CITY OF ALBUQUERQUE

RE: 3050 Todos Santos St NW
Grading and Drainage Plan
Engineer's Stamp Date: 04/16/24
Hydrology File: G10D029K

**WAIVER APPLICATION FROM STORMWATER
QUALITY VOLUME MANAGEMENT ON-SITE**

GRADING PLAN

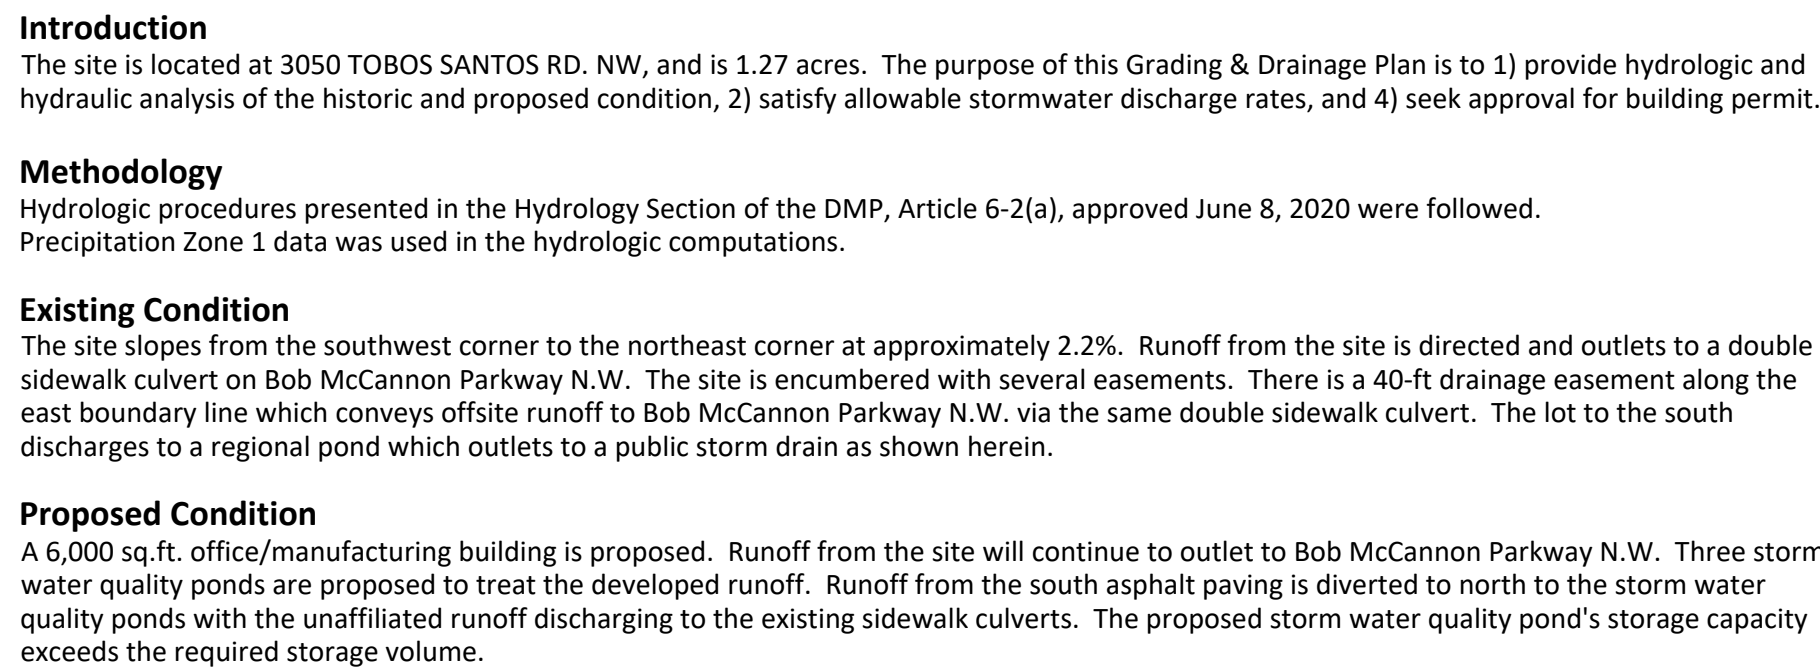
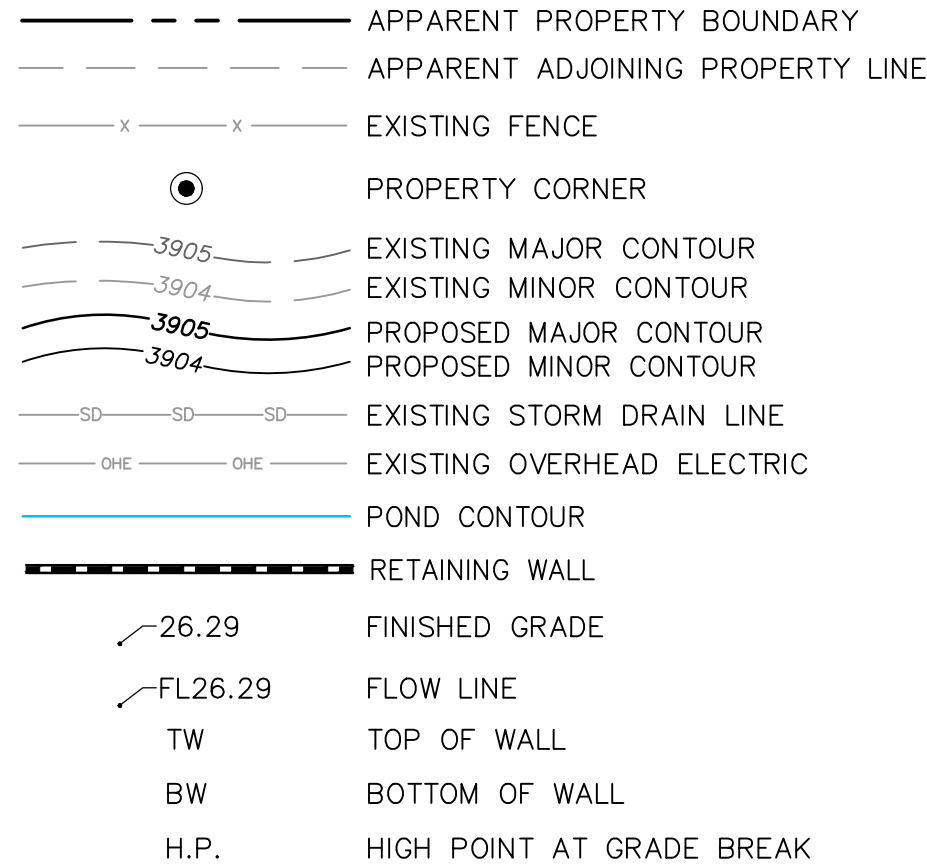
Based upon the information provided in your submittal received 04/18/2024, the Grading & Drainage Plan is approved for Building Permit and Grading Permit. Please attach a copy of this approved plan in the construction sets for Building Permit processing along with a copy of this letter.

1. Engineer's Certification, per the DPM Part 6-14 (F): *Engineer's Certification Checklist For Non-Subdivision* is required.
2. Please provide the executed paper Drainage Covenant (latest revision) printed on one-side only with Exhibit A and a check for **\$25.00** made out to "**Bernalillo County**" for the stormwater quality ponds per Article 6-15(C) of the DPM to Hydrology for review at Plaza de Sol.
3. Please pay the Payment-in-Lieu of **\$ 1,904.00** by emailing the attached approved Waiver Application from Stormwater Quality Volume Management On-site to PLNDRS@cabq.gov. Once this is received, a receipt will then be produced and email back. Follow the instructions on the bottom of the form and pay it at the Treasury in Plaza de Sol. Once paid, please provide me proof of payment.
